NEVIUS ROAD SUBDIVISION

APPLICATION NUMBER 24 DATE April 7, 2005

APPLICANT Nevius Road Subdivision

NEVIUS ROAD SUBDIVISION

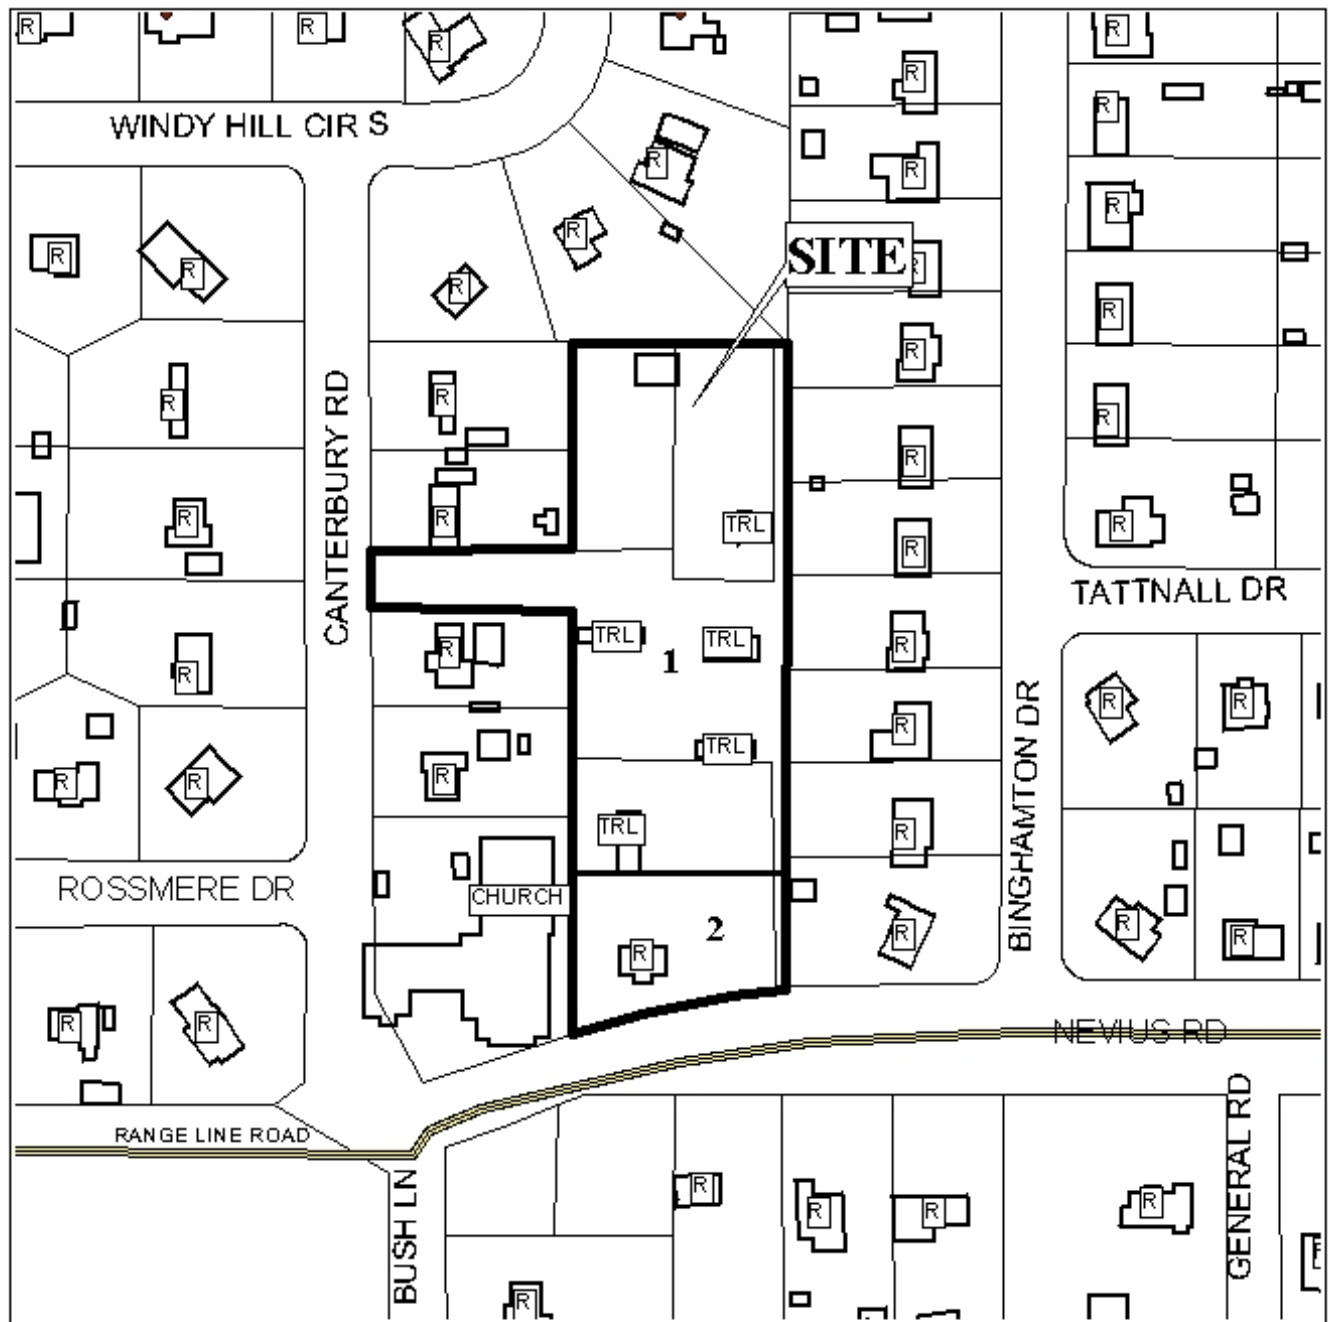
The proposed lot 1’s depth to width ratio is approximately 7.6 (depth is 7.6 times the width), which is greater than the 3.5 recommended in Section V.D.3. of the Subdivision Regulations. Lot 1’s high depth to width ratio is due to the flag-shape of the proposed lot. Other lots in the area do not reflect similar width to depth ratios. Furthermore, the flag-shape of proposed lot 1 is not characteristic of other parcels or lots in the area, and thus is not in conformance with Section V.D.1. However, due to the fact that the proposed lot 1 is almost entirely surrounded by lots and parcels that face public streets, the creation of a non flag-shaped lot would be very difficult unless the proposed lots 1 and 2 are combined into one lot. Additionally, the proposed subdivision will correct an existing land-locked situation. Thus a waiver of Sections V.D.1. and V.D.3. could be considered appropriate.

The 25-foot minimum building setback line is not shown, but would be required on the Final Plat.

This site is located in Mobile County, thus a note should be placed on the Final Plat stating that any lots which are developed commercially and adjoin residentially developed property must provide a buffer, in compliance with Section V.A.7. of the Subdivision Regulations.

With a waiver of Sections V.D.1. and V.D.3. of the Subdivision Regulations, the plat is recommended for Tentative Approval, subject to the following conditions: 1) the placement of a note on the Final Plat stating that any lots which are developed commercially and adjoin residentially developed property must provide a buffer, in compliance with Section V.A.7. of the Subdivision Regulations; and 2) depiction on the final plat of the 25-foot minimum building setback line.
